# Release 1.2

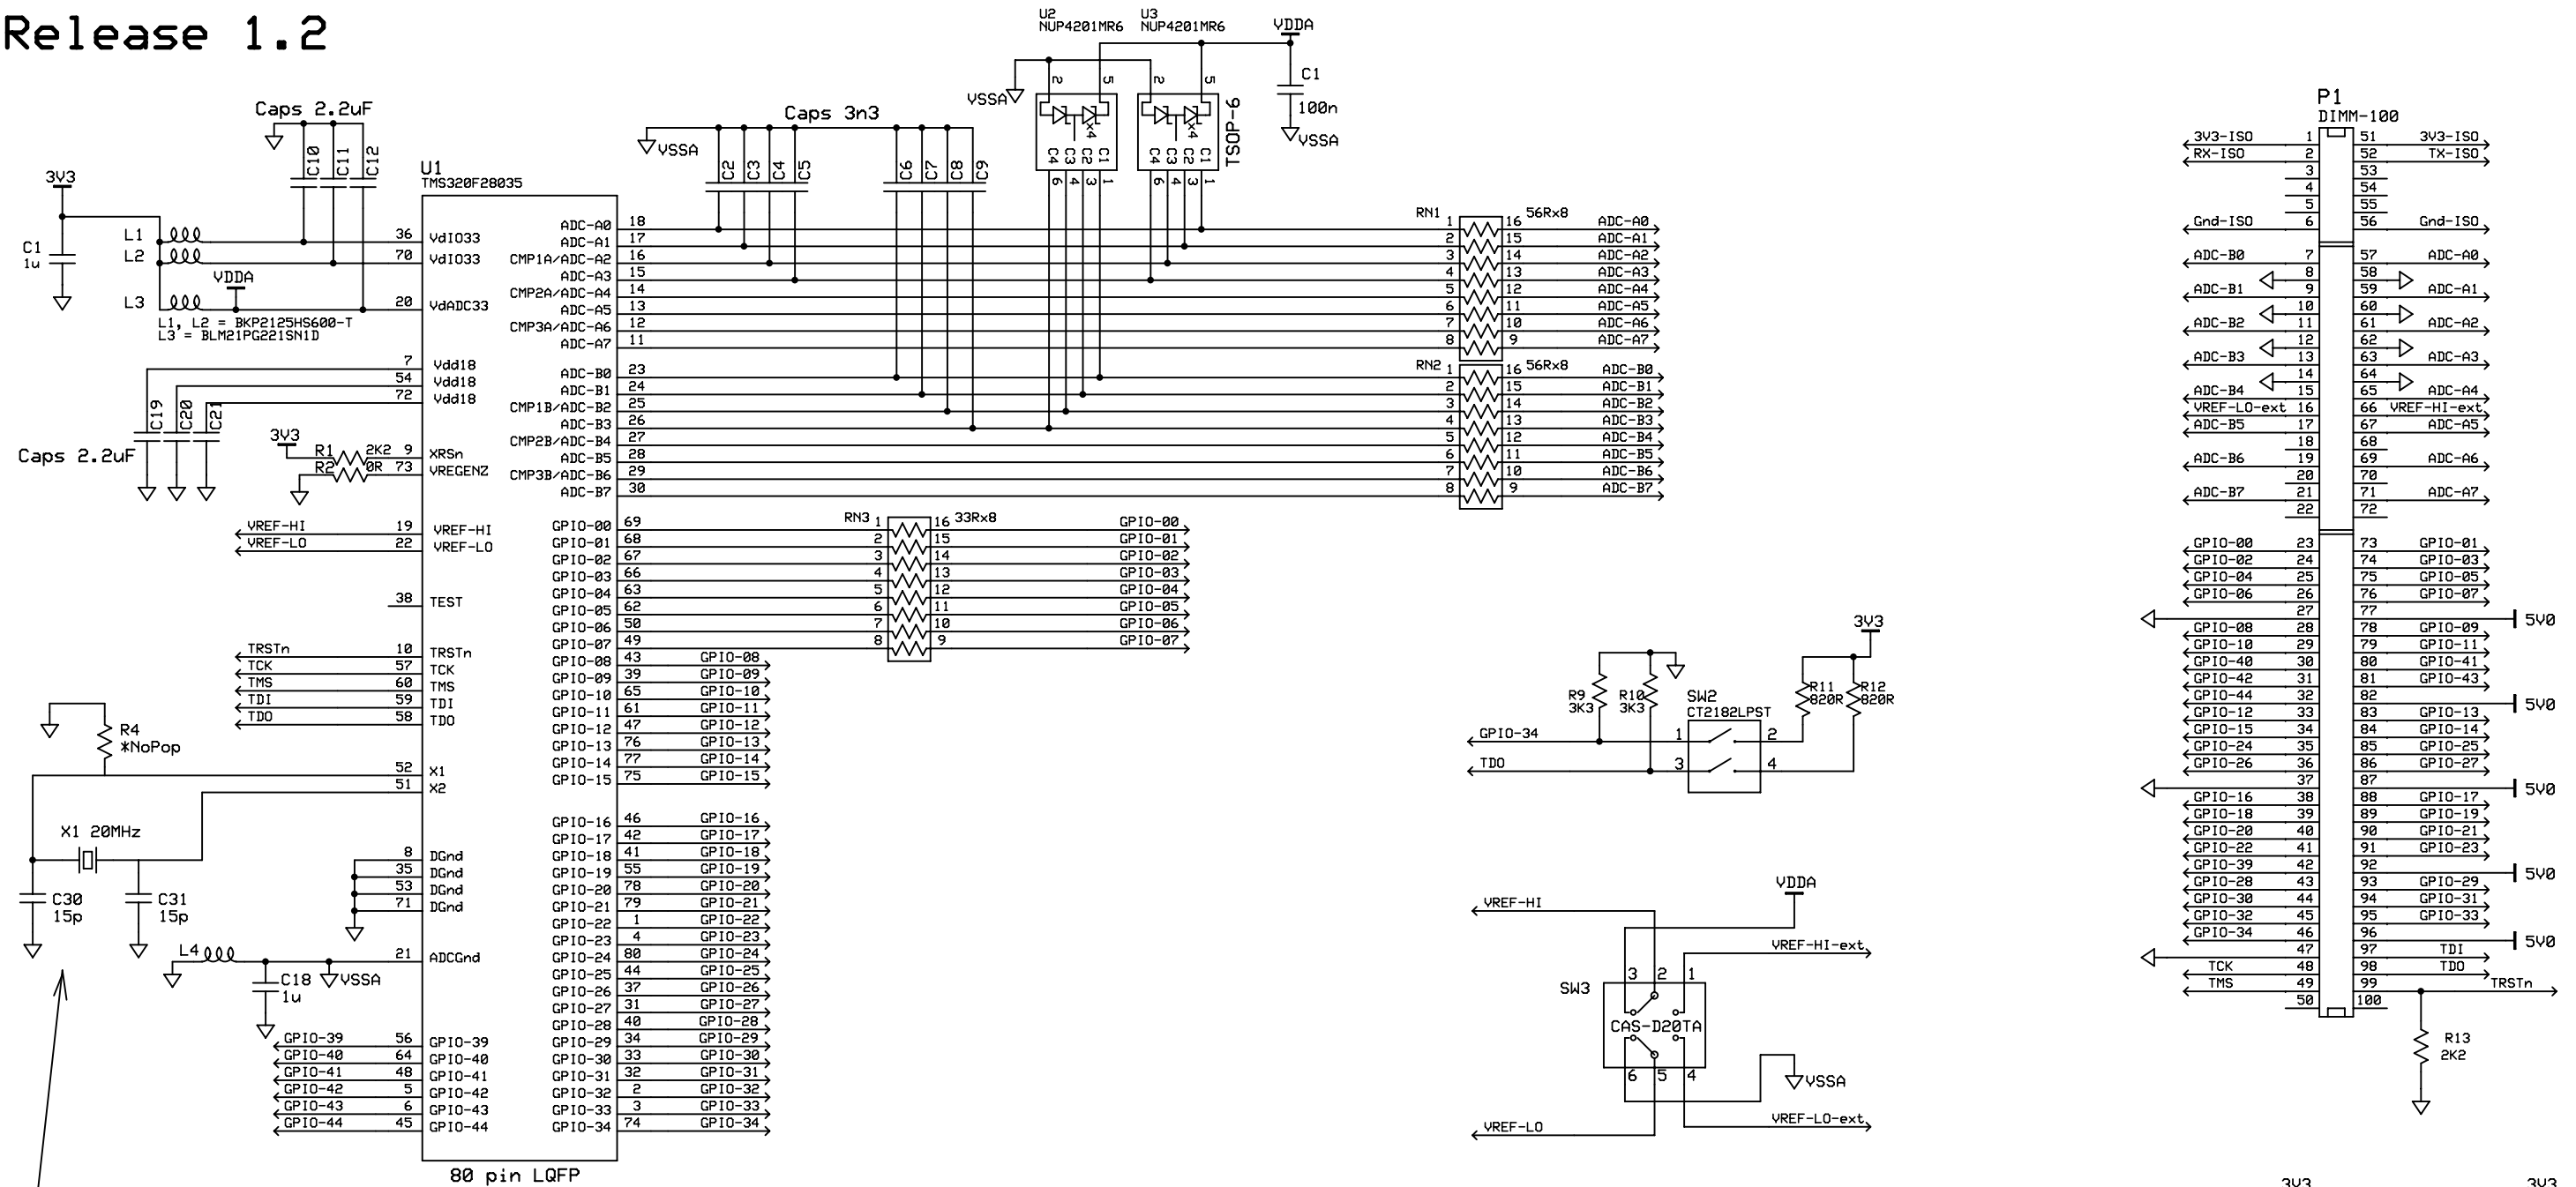
If only the internal crystal is used,  
X1, C30, and 31 should not be populated  
and R4 should be changed to a 0ohm resistor
